PIC18F47J53 Family Silicon Errata and Data Sheet Clarification

The PIC18F47J53 Family devices that you have received conform functionally to the current Device Data Sheet (DS39964B), except for the anomalies described in this document.

The following typographic corrections and clarifications are to be noted for the latest version of the device data sheet (DS39964B):

FIGURE 2-3 FREQUENCY vs. ESR PERFORMANCE FOR SUGGESTED VCAP

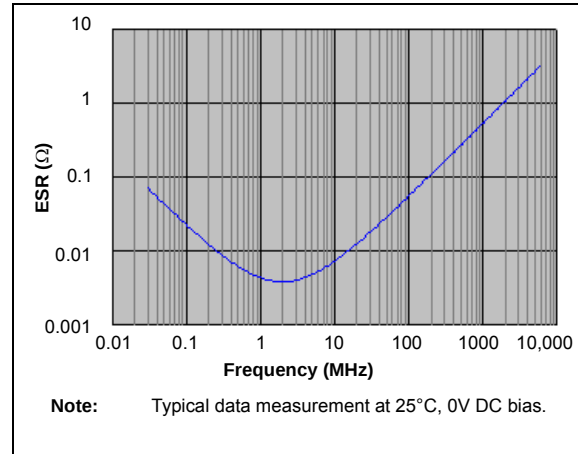
Section 2.4 “Voltage Regulator Pins (VCAP/VDDCORE)” has been replaced with a new and more detailed section. The entire text follows:

On “F” devices, a low-ESR ($< 5\Omega$) capacitor is required on the VCAP/VDDCORE pin to stabilize the voltage regulator output voltage. The VCAP/VDDCORE pin must not be connected to VDD and must use a capacitor of $10\ \mu\text{F}$ connected to ground. The type can be ceramic or tantalum. Suitable examples of capacitors are shown in [Table 2-1](#). Capacitors with equivalent specification can be used.

Designers may use [Figure 2-3](#) to evaluate ESR equivalence of candidate devices.

It is recommended that the trace length not exceed 0.25 inch (6 mm). Refer to [Section 31.0 “Electrical Characteristics”](#) for additional information.

FIGURE 2-4 DC BIAS VOLTAGE vs. CAPACITANCE CHARACTERISTICS

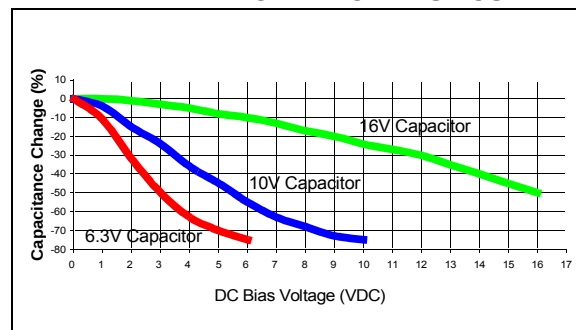
In addition to temperature tolerance, the effective capacitance of large value ceramic capacitors can vary substantially, based on the amount of DC voltage applied to the capacitor. This effect can be very significant, but is often overlooked or is not always documented.

A typical DC bias voltage vs. capacitance graph for 16V, 10V and 6.3V rated capacitors is shown in Figure 2-4.

When selecting a ceramic capacitor to be used with the internal voltage regulator, it is suggested to select a high-voltage rating, so that the operating voltage is a small percentage of the maximum rated capacitor voltage. For example, choose a ceramic capacitor rated at 16V for the 2.5V core voltage. Suggested capacitors are shown in Table 2-1.
